LOCATION
Manor Farm
Graveley

PROJECT NUMBER
BH23023

Manor Farm, Graveley

This 'Design and Heritage' statement has been prepared by Benchmark Architects in support of a planning application for Grade II Listed home Manor Farm, Graveley formerly known as Chesfield Manor.

House & Extension- Ground Floor Plan

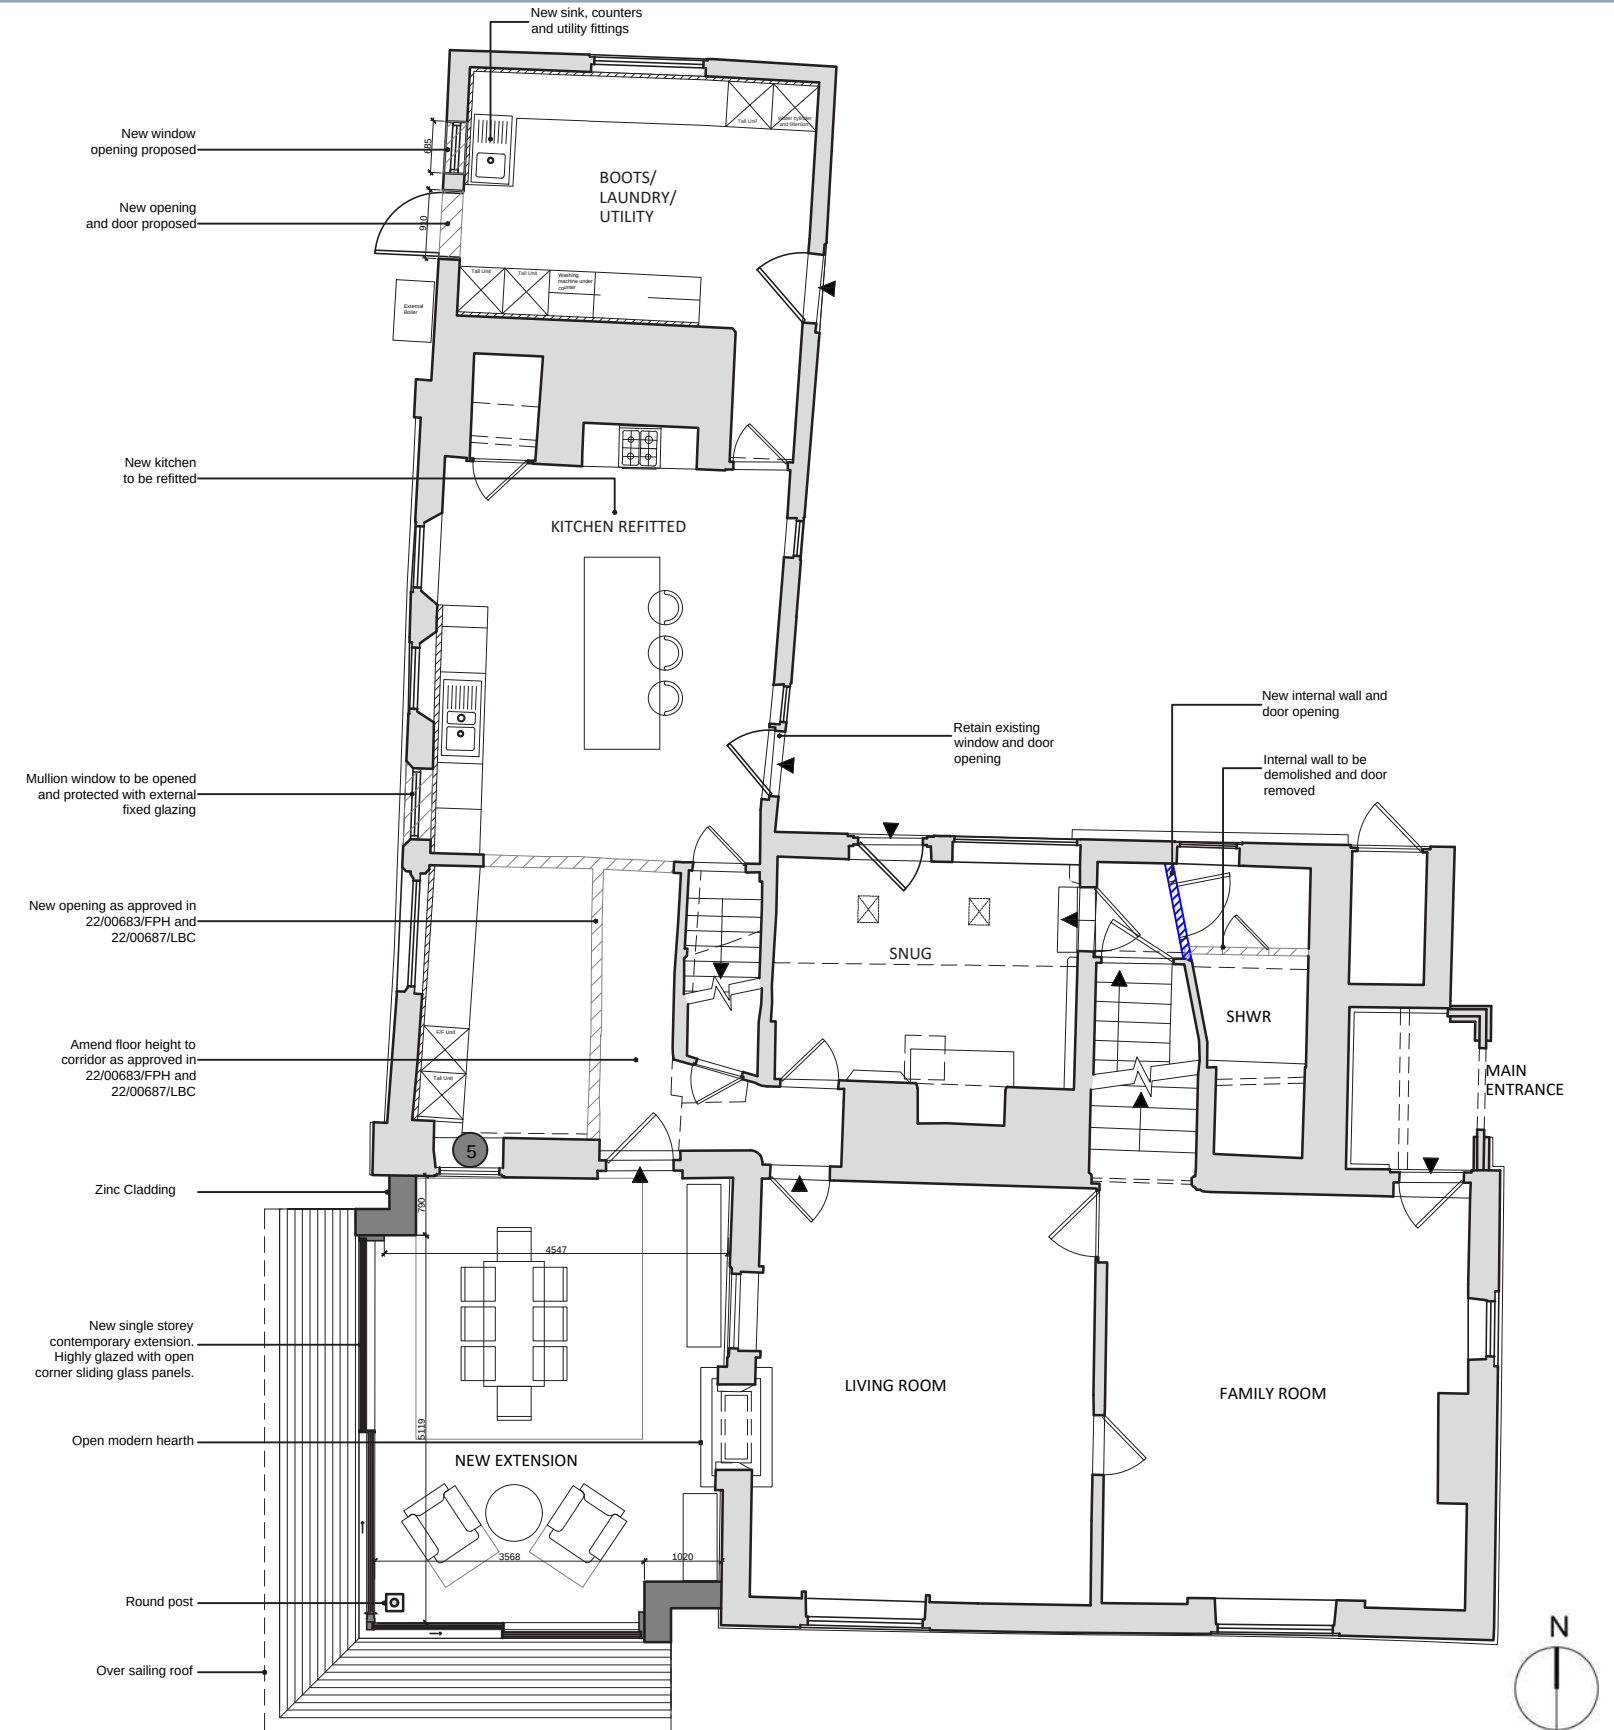
1. The proposed changes are limited to the ground floor and that the new opening from the Boots/Laundry/Utility and the removal of internal partitions in the north range and the raising of an area of floor were all permitted under the approved applications 22/00683/FPH and 22/00687/LBC.

2. No objection to the opening up of the mullion window on the west elevation, assumed relocated from the stair tower or south range. Whilst it is proposed to protect this window by fixing external glazing, I am not entirely convinced by this approach.

3. Enlarging the doorway on the south elevation of the north range may prove problematic in that the pre-application submission refers to this part of the building being of high or highest significance. There is no convincing justification to enlarge this opening and so this aspect of the proposal is discouraged.

4. On the one hand the pre-submission states that the removal of the east door from kitchen is required to help clarify the confused access to the building and yet the concept proposals indicate the door and quarter-pane window alongside being replaced by a single larger window. The door is a flush-panelled type which, in my opinion, contributes positively to the building's external appearance but may well have

been installed as part of the refurbishment works undertaken under ref:99/00835/1LB. In my opinion whilst loss of the door would be disappointing there is not a compelling heritage case to retain it. The quarter pane window on the other hand, would if retained, complement the other quarter-pane window in the same expanse of brickwork and I recommend that this is either retained (or if beyond repair), replaced like-for-like.

5. I am prepared to support the proposed opening up of the later chimney stack to create a dual accessed fireplace between the living room and proposed dining room.

6. Just to clarify matters with respect to the proposed French doors to the Boots/Laundry/Utility. Whilst it is correct to say that the opening was approved in 2022, this opening would have sat behind and therefore screened by a plant room addition. In my opinion, whilst French doors may not be objectionable, there is a case to suggest that with this being the service end of the property it would seem more appropriate to encourage a single service door as opposed to formal French doors. It was also brought to the officer's attention that the applicant would like to install a new boiler on the hard standing area here where the extension was to be built (unobjectionable). Although it is suggested that the base of the unimplemented extension becomes effectively a patio, the combination of boiler and access to Boots/Laundry/Utility is such that it arguably does not lend itself to the best position for a patio and French doors.

1. As stated in the submission, the major change would be the proposed single storey single bay and where it says that 'this will enhance the layout of the whole building without competing with the dominant façades'. First and foremost, I am prepared to consider and infill here if undertaken sensitively and respecting the significance of the host building.

The proposed changes on the ground floor remain as above. In addition to these changes, a new wall with door opening is proposed for the shower room on ground floor. On the first floor, a new wall with a door opening is proposed to create a corridor that separates the bedroom from general circulation.

The proposed opening up of the mullion window remains as above.

The design proposal keeps the existing door and opening as existing. This door will lead into the newly proposed extension.

The design proposes to retain the window and door opening as existing, however the existing door and frame to the kitchen is cracked and warped, it will be replaced by new door and frame of similar style. The existing softwood window is in poor condition which will be replaced by a new hardwood window of similar style.

The proposal of the dual accessed fireplace between the living room and extension will remain.

The design proposal shows new door and a window opening instead of the French doors to the Boots/Laundry/Utility. The previously proposed extension at this side of the house is not to be realized, however as per the applicant's requirement an external boiler will be placed near the Boots/Laundry/Utility space on the outside.

The proposed extension will be contemporary in appearance with glazing panels opening at the corner. The extension will connect the two wings of the house and will add an additional space for the kitchen. The design and appearance of the extension is shown in the drawings in the following pages.

House & Extension - First Floor Plan

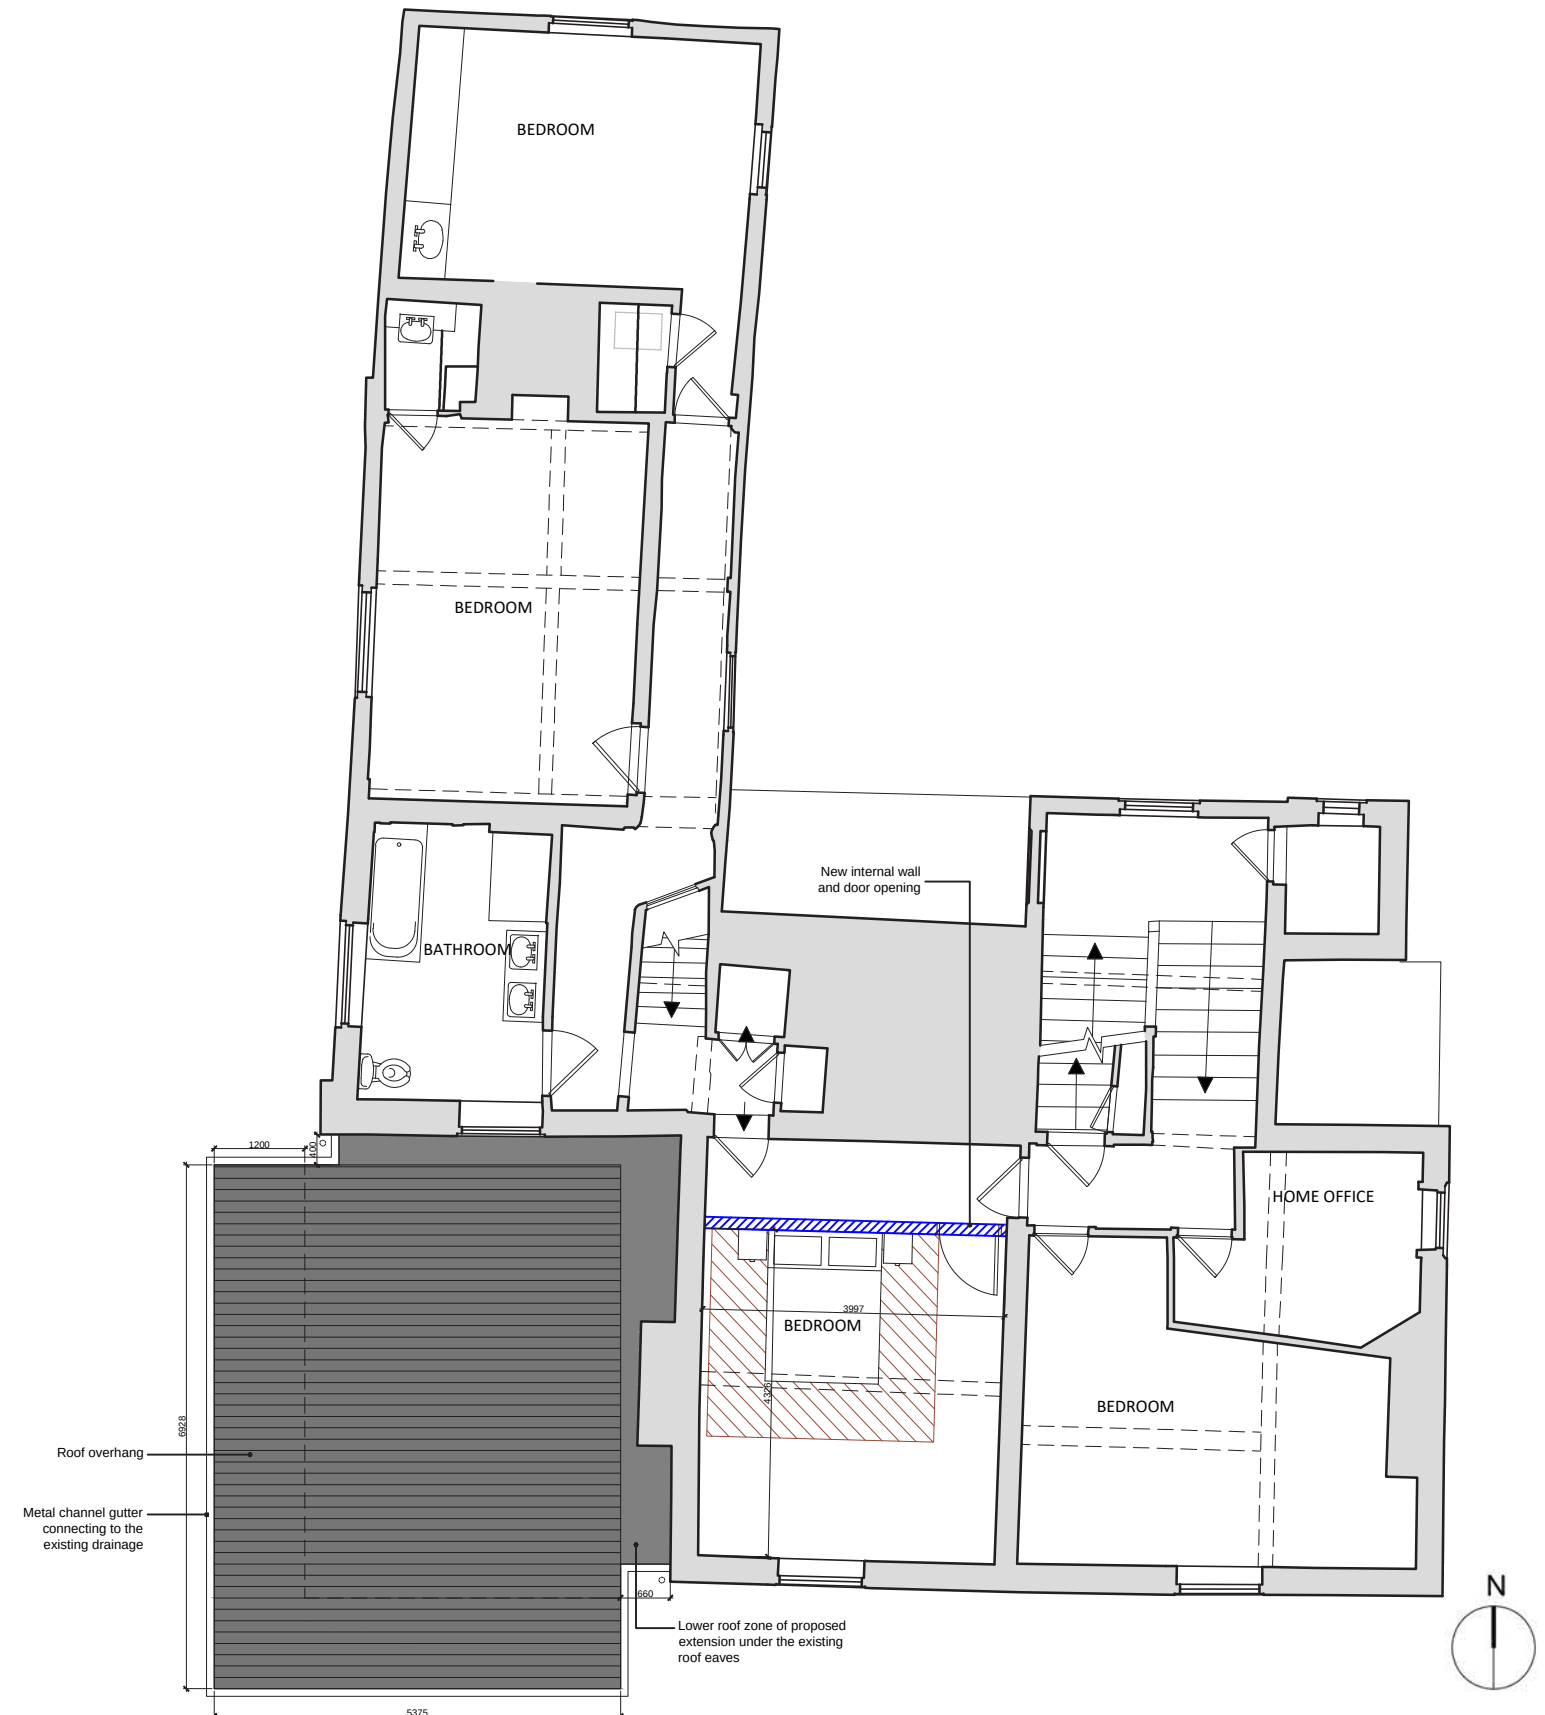
2. As stated in the submission, 'the extension will be contemporary with a low-pitched black zinc roof and a high level of glazing. The glazing will project beyond the main structure of the extension to ensure that views into the garden areas and to the church ruins are achieved. The over sailing roof will minimise the risk of overheating'. Whilst I raise no objection to the choice of materials or the amount of glazing, the substantial roof projection will impact upon the reading of the south and west facing façades considered as possessing high and highest significance respectively.

3. I place minimal weight to the aspiration of being able to enjoy views of the walled garden, neighbouring countryside, and the remains of the Church of St. Etheldreda (grade II* and a scheduled monument). The question is whether the roof projection would be a modest, polite intrusion or a more severe interruption to the existing building line. In my view, the projection is the most challenging aspect of the design and there may be other measures that could compensate for any perceived overheating or maybe simply setting the extension further back from the front building line on both sides.

The revised proposal has reduced this overhang/projecting eaves. We do not feel that it will impact significantly on the south and west façades.

Similar to the concern above we feel the projection of the roof of proposed extension is not a severe change to the existing building line.

Outbuildings - Ground Floor Plan

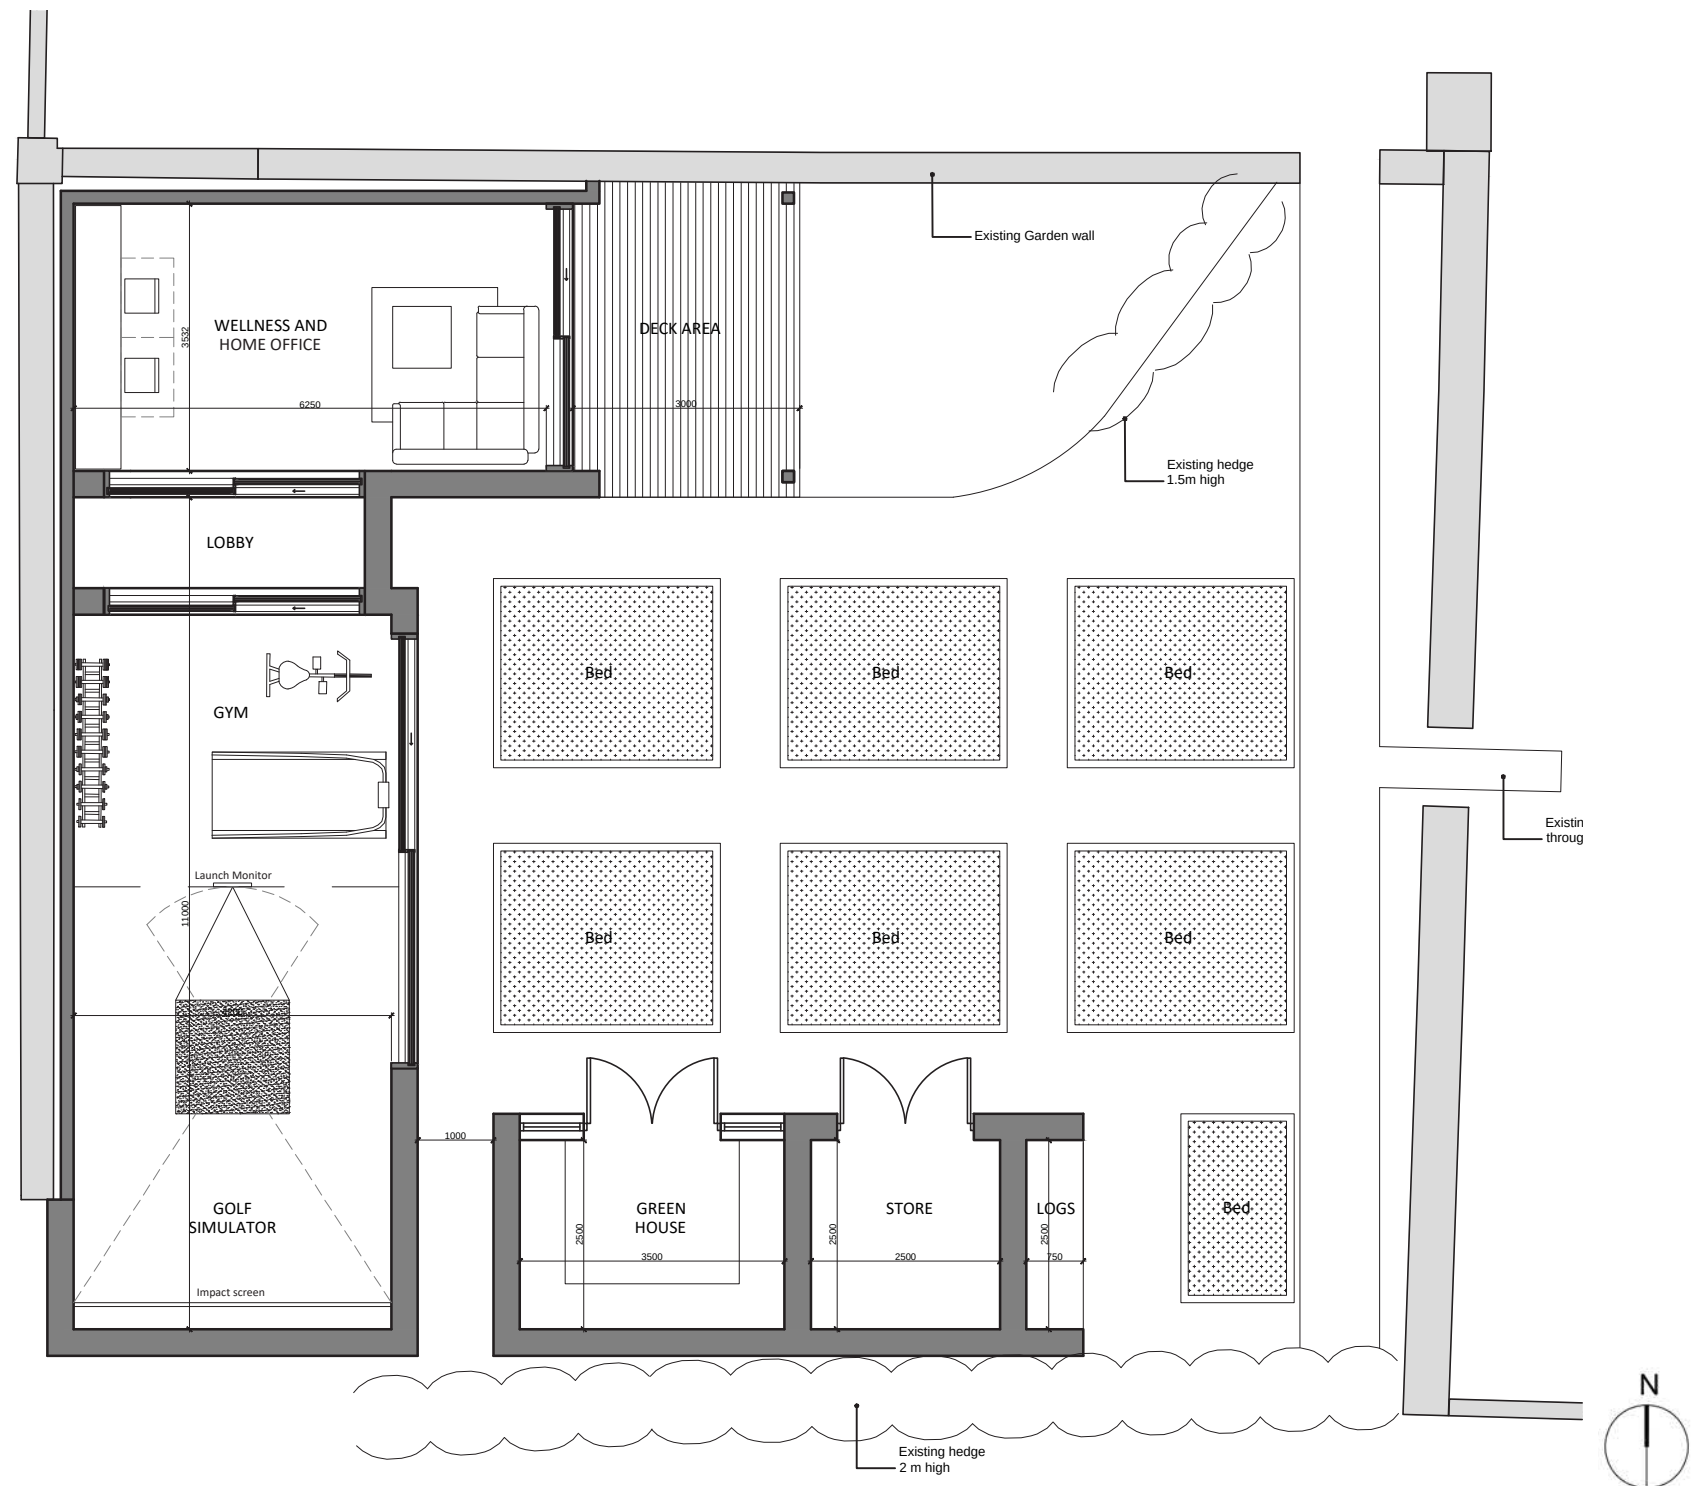
1. At page 5 of the pre-application submission, it states the following: 'The only outbuildings to service the main house is a modern single garage built abutting the listed wall. This can no longer be accessed from the driveway and is too small for modern cars. This is currently used as a temporary home-gym. To the south-west the Kitchen Garden contains early to late C20th garden buildings along the western boundary'. This aspect of the proposal is arguably more contentious than the extension to the main house. The OS map regression below identifies the site during the late C19 and early C20 and the walled garden with buildings is clearly shown. Looking at the planning history and particularly photos on appn ref:00/01123/1LB, the outbuildings against the west wall of the walled vegetable garden show that the structures were in poor condition. Other photos show a chimney stack that would have served a building in the north-east corner of this enclosure. What we see today is the implemented scheme approved in 2001. It is fair to say that the softwood framing to the conservatory/greenhouse has not stood up particularly well to weathering in the last 23 years. Having said that, the scheme makes a positive contribution to the walled garden and to the wider setting of Manor Farmhouse. Contextually it is highly appropriate. Whilst I probably cannot resist the demolition of C21 structures, the question this raises is would the proposal make an equally or better contribution to Manor Farmhouse's setting?

2. The weatherboarding and large glazed areas do not have the architectural vocabulary of buildings expected to be found in a walled garden setting. Additionally, whilst I appreciate the benefits of introducing solar PV to the roof, this will also instil the perception that

rather than being a building ancillary in character, this building adopts a rather domestic appearance giving the perception of an annexe as opposed to garden buildings.

3. The justification of the use of the new building is not particularly compelling although I am empathetic to a home office use. I am also mindful that as the land in the ownership of Manor Farm has diminished over recent years, so the opportunity to provide such facilities outside of the residential garden grounds cannot be realised.

6. The proposed depth of this building, therefore, has practical repercussions. In short, if a replacement building is to be successful here then I believe the design should be revisited to create a building that is more traditional in appearance, thus more respectful to its context.

We feel that the proposed garden outbuildings will make a positive contribution to the Manor Farmhouse as it will enhance the quality of the garden space by the rebuilding of structures in the kitchen garden.

In the design proposal we are not proposing PV panels on the roofs to maintain the domestic nature of the proposed spaces.

In addition to the wellness/home office space with an extended deck space, a green house along with a store space is also proposed. A space to accommodate a golf simulator and gym is also proposed.

We feel contemporary out buildings in appearance will sit well in the garden space and complement the newly proposed extension of the main house, maintaining a connection between the two parts of the Manor Farmhouse.
